Access Compliance Report

Public Rights-of-Way

(Curb Ramps)

Intersection ID: 47983	Main Street: SPRINGS_MILL_RD	Cross Street: WHEAT_RIDGE_RD	Location: NW
ADA ID: 96C7CBFB930E	Ramp Type: PerpDiag	Initial Pass/Fail: Fail	Overall Compliance: No
Severity Score: 8.75			
Codes/Mitigation Info/Possible Solution		Field Measurements/Component Compliance

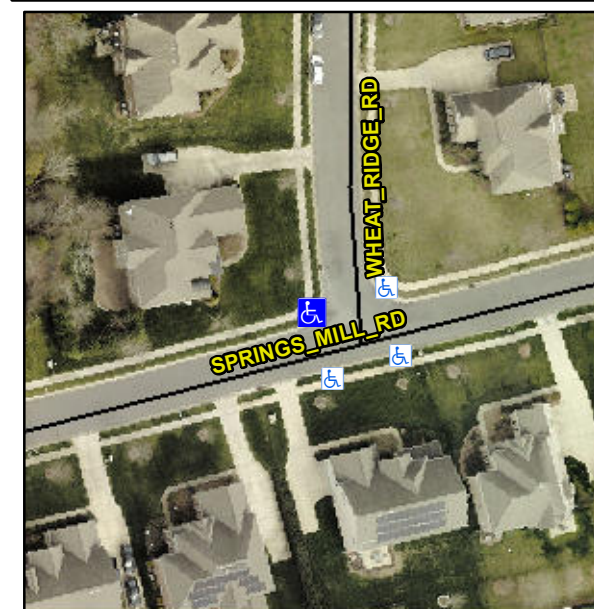
Not Found, R304.5.1

Compliance	Description	Data	Compliance	Description	Data
N/A	Ramp Length (in)	47.0	Yes	Ramp Slope (%)	5.8
No	Ramp Width (in)	47.0	Yes	Ramp XSlope (%)	1.0
N/A	Flare Type LT	N/A	N/A	Flare Type RT	N/A
N/A	Flare Slope LT (%)	N/A	N/A	Flare Slope RT (%)	N/A
N/A	Flare Traversable LT?	N/A	N/A	Flare Traversable RT?	N/A
N/A	Landing Length (in)	N/A	N/A	DWS Provided?	N/A
N/A	Landing Width (in)	N/A	N/A	DWS Contrast?	N/A
N/A	Landing Slope (%)	N/A	N/A	DWS Length (in)	N/A
N/A	Landing X Slope (%)	N/A	N/A	DWS Full Width?	N/A
N/A	Landing Curb? (Y/N)	N/A	N/A	DWS Offset (in)	N/A
N/A	Shared Landing?	N/A			
N/A	Gutter Ponding?	N/A	N/A	Gutter Slope (%)	N/A
N/A	Gutter Lip Ht (in)	N/A	N/A	Gutter X Slope (%)	N/A
N/A	Painted X Walk1?	No	N/A	Painted X Walk2?	No
	X Walk 1 Direction	To S		X Walk 2 Direction	To E
N/A	X Walk 1 Width (in)	N/A	N/A	X Walk 2 Width (in)	N/A
	X Walk 1 Slope (%)	2.3		X Walk 2 Slope (%)	0.7
	X Walk 1 X Slope (%)	0.9		X Walk 2 X Slope (%)	1.1

Remove & Replace Curb Ramp With Two New Directional Ramps or Equivalent.
